UNITED STATES PATENT AND TRADEMARK OFFICE

APPLICATION NO.	FILING DATE	FIRST NAMED INVENTOR	ATTORNEY DOCKET NO.	CONFIRMATION NO.
09/892,883	06/28/2001	Hong Man Moon	8733.426.00	3032
7590 07/14/2004				
MCKENNA LONG & ALDRIGE LLP		EXAMINER		
1900 K STREET, N.W.		RUDE, TIMOTHY L		
WASHINGTON, DC 20006				
		ART UNIT	PAPER NUMBER	
		2871

Office Action Summary	Application No.	Applicant(s)	
	09/892,883	MOON ET AL.	
	Examiner	Art Unit	
	Timothy L Rude	2871

DETAILED ACTION

FIG. 5a

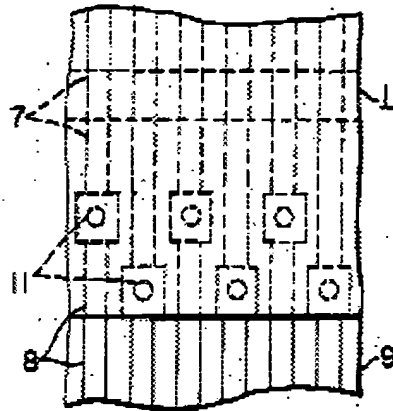
Tanaka teaches in Figures 1-5 the use of terminal and conductor (Applicant's line) spacing in the ranges of 1.5mm or more (col. 1, lines 5-18) and 1.0mm or more (col. 1, lines 22-34) in order to connect them to an external circuit.

Tanaka is evidence that ordinary workers in the art of liquid crystals would find the reason, suggestion, or motivation to use a predetermined distance that is greater than or equal to 1mm; equal to or greater than 1mm and less than or equal to 1.5mm; or greater than 1.5mm in order to connect them to an external circuit.

Therefore, it would have been obvious to one having ordinary skill in the art of liquid crystals at the time the invention was made to modify the LCD of APA with the predetermined distance of Tanaka that is greater than or equal to 1mm; equal to or greater than 1mm and less than or equal to 1.5mm; or greater than 1.5mm in order to connect them to an external circuit.
